South Coast Air Quality Management District

Subject: Addendum to the Determination of Compliance (DOC) for CPV Sentinel's (CPV) Proposed 850 Megawatt Power Plant Project (Facility ID No. 152707), to be located at 62575 Power Line Rd, Desert Hot Springs, CA 92440; (07-AFC-3)

At this time AQMD has completed its review of the additional information regarding project operations and offsets submitted by CPV and prepared an Addendum to the Determination of Compliance (DOC) relative to the PDOC (dated May 7, 2008) and FDOC (dated August 29, 2009). Based on our review of the additional information provided by CPV, AQMD has determined that the CPV Project complies with all applicable requirements of the local, state and federal air quality Rules and Regulations. Enclosed please find a copy of the Addendum to the DOC Analysis and the draft Title V Facility Permit to Construct for the CPV project.

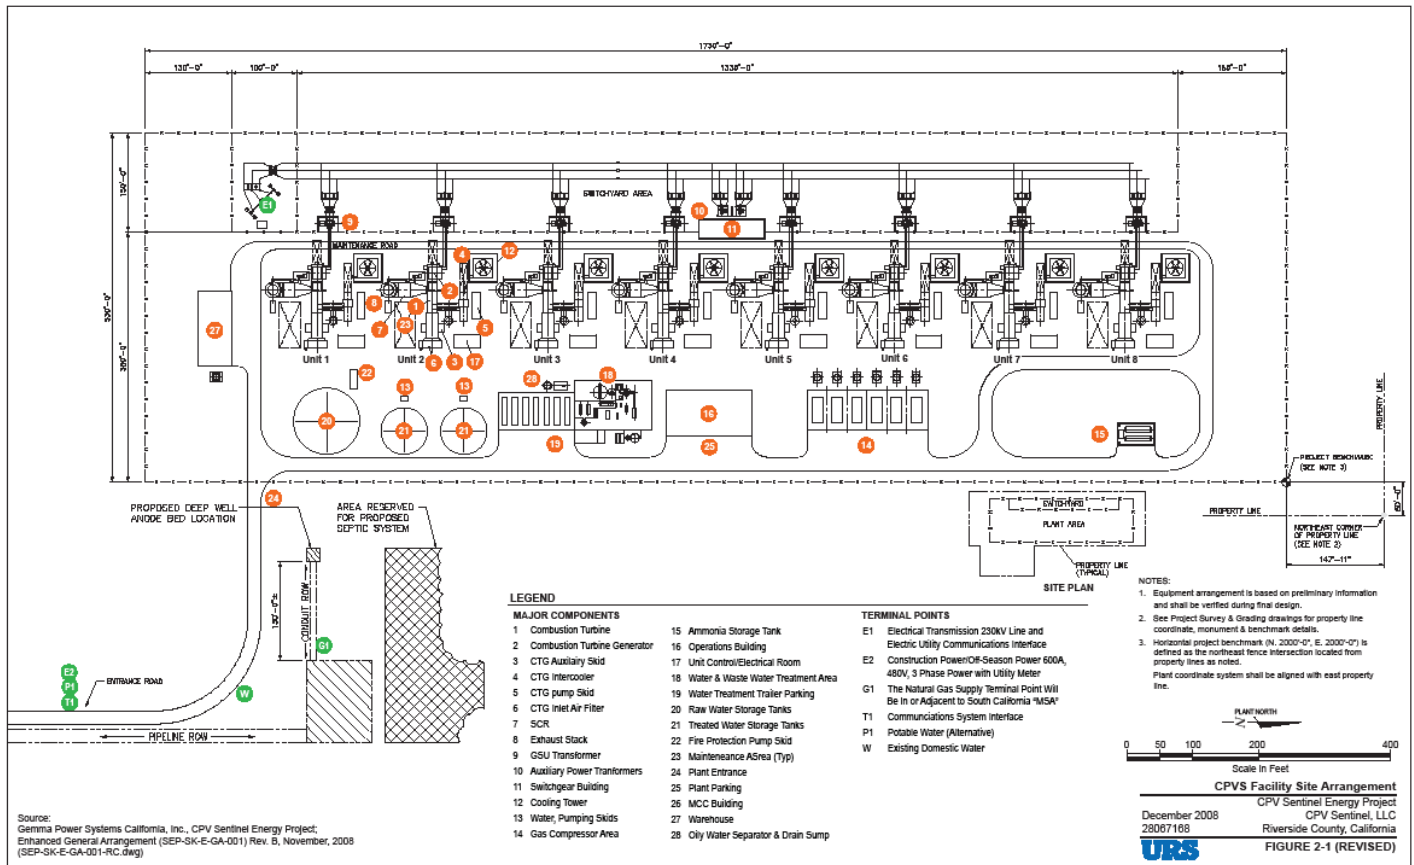
- Remove the two proposed cooling towers, and provide one cooling tower per turbine
- Eliminate the operations buildings
- Remove one warehouse building and relocate another warehouse building
- Relocate the switchgear building
- Relocate the treated water storage tanks, water pumping skids and water treatment trailer parking

The revised site plan shown above was prepared for CPV Sentinel by URS and shows the general layout of the proposed facility. There will be one cooling tower per turbine and a couple of buildings were moved to different locations on the property. The project site is located in a remote area surrounded by air turbines and an Edison substation to the west. To the southeast is the Indigo Energy Facility (1.8 miles). To the north, east and south are Wind Farms. The site locale is an industrial portion of the unincorporated area of Riverside County. The nearest residence is 330 feet east of the Facility and the applicant has an option to acquire the property. The second group of nearest residence is located 2.5 km (8,800 ft) southeast of the Facility.
